Access Compliance Report

Public Rights-of-Way

(Curb Ramps)

Intersection ID: 53157	Main Street: DALLAS_BAY_RD	Cross Street: HAMILTON_BRIDGE_RD	Location: SW
ADA ID: 361DD76CDEEB	Ramp Type: Perp	Initial Pass/Fail: Fail	Overall Compliance: No
Severity Score: 22.5			
Codes/Mitigation Info/Possible Solution		Field Measurements/Component Compliance

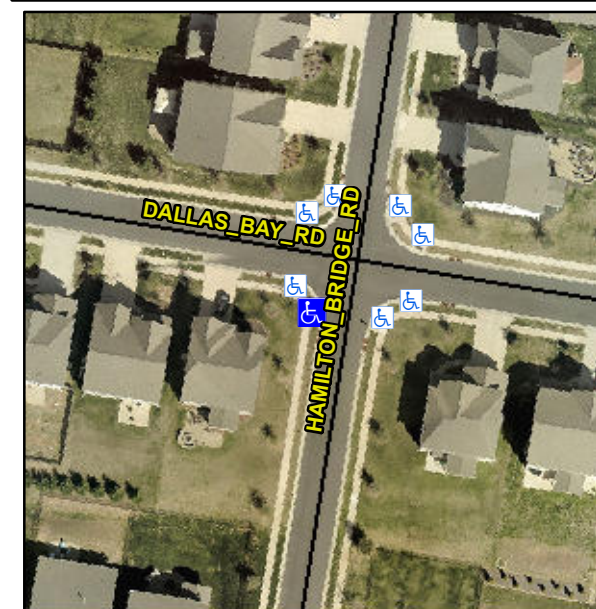
Not Found, R304.5.1, R304.2.2, R304.5.3

Compliance	Description	Data	Compliance	Description	Data
N/A	Ramp Length (in)	50.0	No	Ramp Slope (%)	9.4
No	Ramp Width (in)	47.5	No	Ramp XSlope (%)	2.1
N/A	Flare Type LT	N/A	N/A	Flare Type RT	N/A
N/A	Flare Slope LT (%)	N/A	N/A	Flare Slope RT (%)	N/A
N/A	Flare Traversable LT?	N/A	N/A	Flare Traversable RT?	N/A
N/A	Landing Length (in)	N/A	N/A	DWS Provided?	N/A
N/A	Landing Width (in)	N/A	N/A	DWS Contrast?	N/A
N/A	Landing Slope (%)	N/A	N/A	DWS Length (in)	N/A
N/A	Landing X Slope (%)	N/A	N/A	DWS Full Width?	N/A
N/A	Landing Curb? (Y/N)	N/A	N/A	DWS Offset (in)	N/A
N/A	Shared Landing?	N/A			
N/A	Gutter Ponding?	N/A	N/A	Gutter Slope (%)	N/A
N/A	Gutter Lip Ht (in)	1.0	N/A	Gutter X Slope (%)	N/A
N/A	Painted X Walk1?	No	N/A	Painted X Walk2?	N/A
	X Walk 1 Direction	To SE		X Walk 2 Direction	N/A
N/A	X Walk 1 Width (in)	N/A	N/A	X Walk 2 Width (in)	N/A
	X Walk 1 Slope (%)	4.9		X Walk 2 Slope (%)	N/A
	X Walk 1 X Slope (%)	3.5		X Walk 2 X Slope (%)	N/A

Remove & Replace Entire Ramp.
